**Record of Decision Remedial Alternative Selection for the D-Area  
Burning/Rubble Pits (431-D and 431-1D)**

**WSRC-RP-96-867  
Revision 1  
February 1997**

The 45-day public comment period for the Statement of Basis/Proposed Plan for the D-Area Burning/Rubble Pits (431-D and 431-1D) (U) began on September 17, 1996 and ended on October 31, 1996. A public meeting was held on October 15, 1996. Specific comments and responses are found below. The comments are italicized and the responses are bolded.

Figure 4. Schedule for the Corrective Measures Implementation/Remedial Action Report

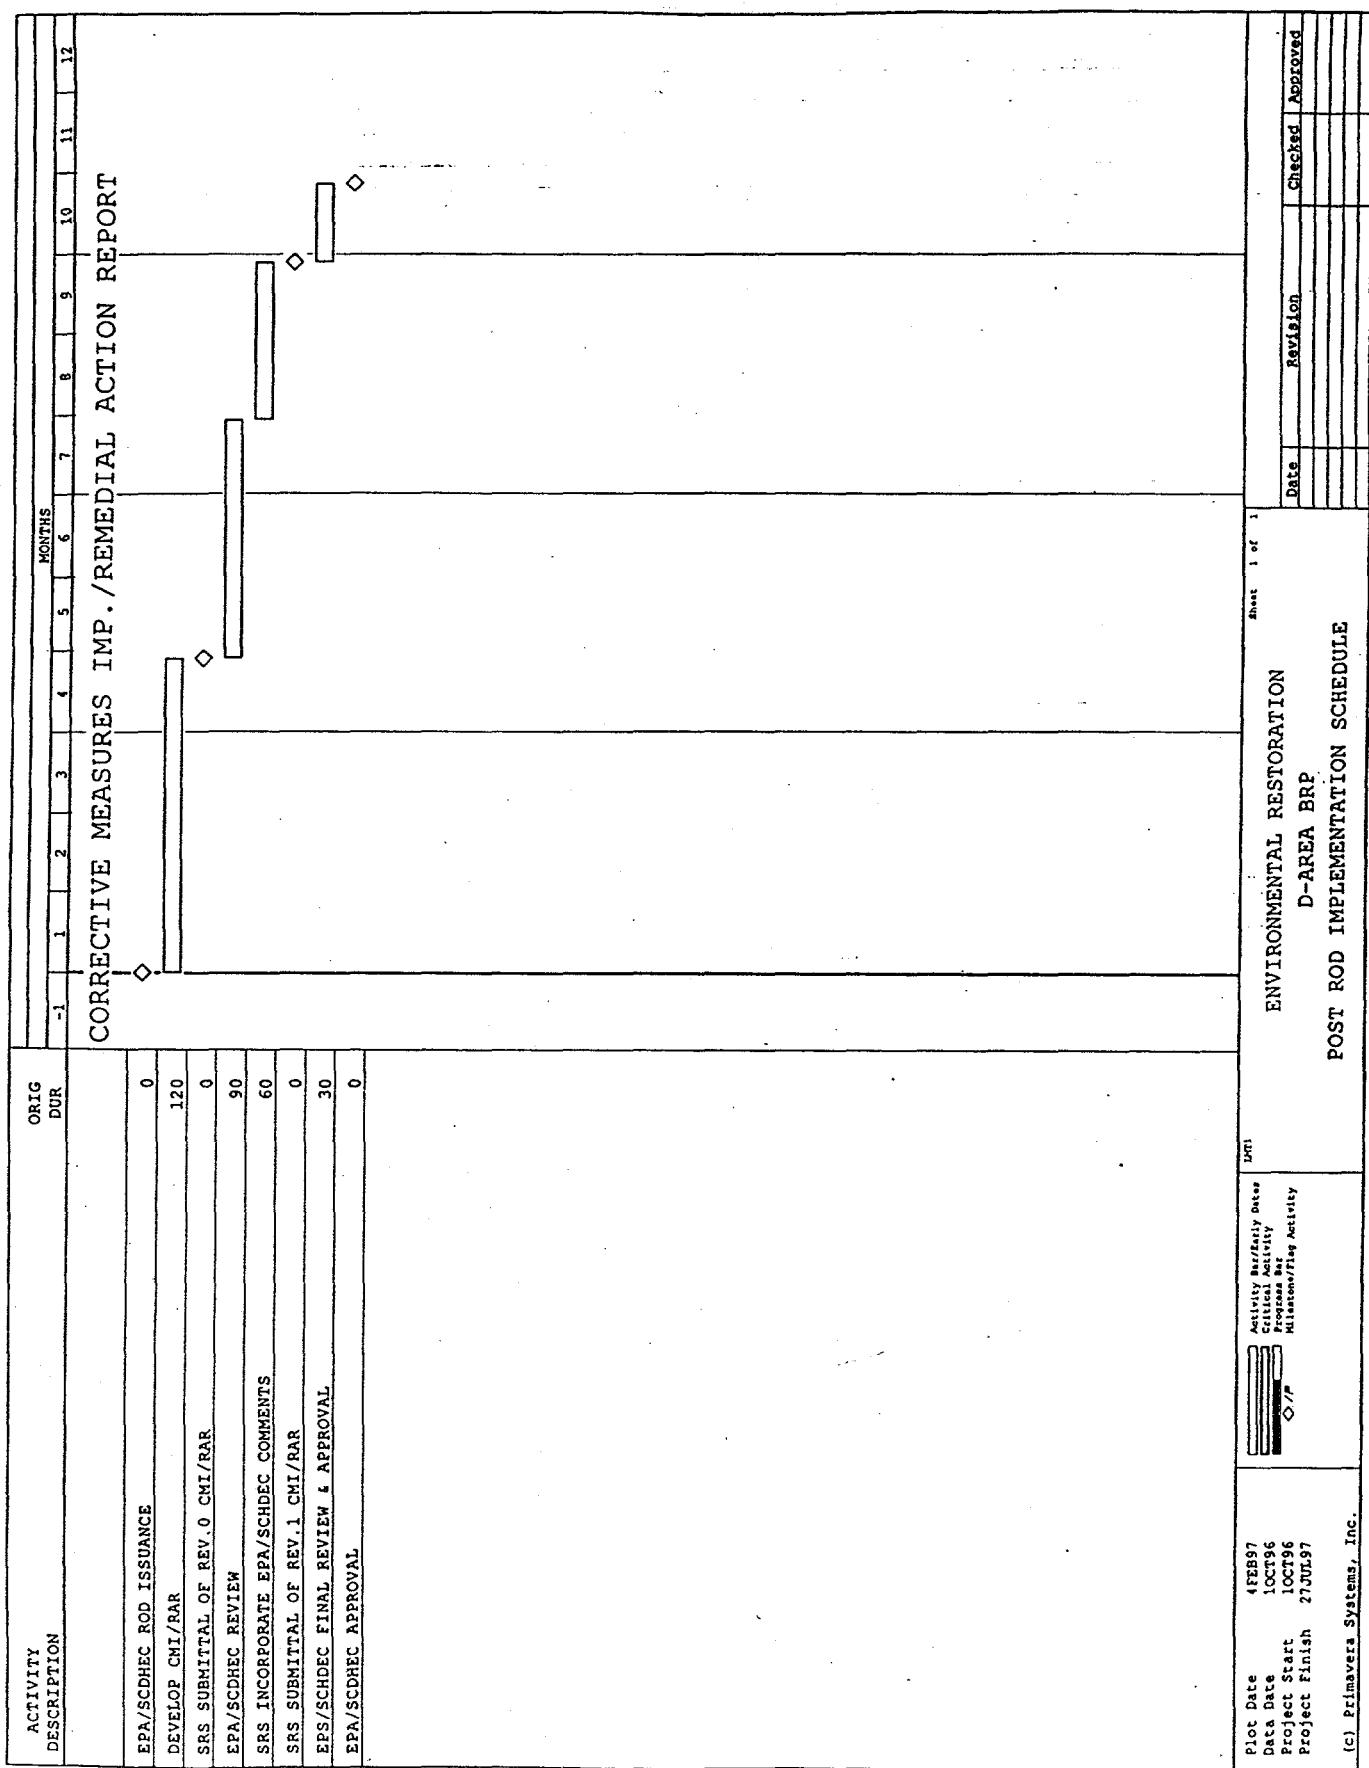
As agreed to among the parties, all RODs, except RODs for no action, will include post-ROD implementation schedules. These schedules should include all post-ROD primary documents and their dates for submission. The post-ROD schedule for RODs which do not address the full scope of the operable unit addressed in the approved RFI/RI work plan (e.g., additional work necessary for a medium impacted by the operable unit source) shall include the following milestones for the additional RI/FS additional work:

- 1) date for submission of the work plan;
- 2) major milestone Field Start Date; and
- 3) major milestone ROD Date.

**Response 1) Clarification. SRS is preparing an implementation plan and generic schedule for Institutional Control waste sites. The program will include details on**
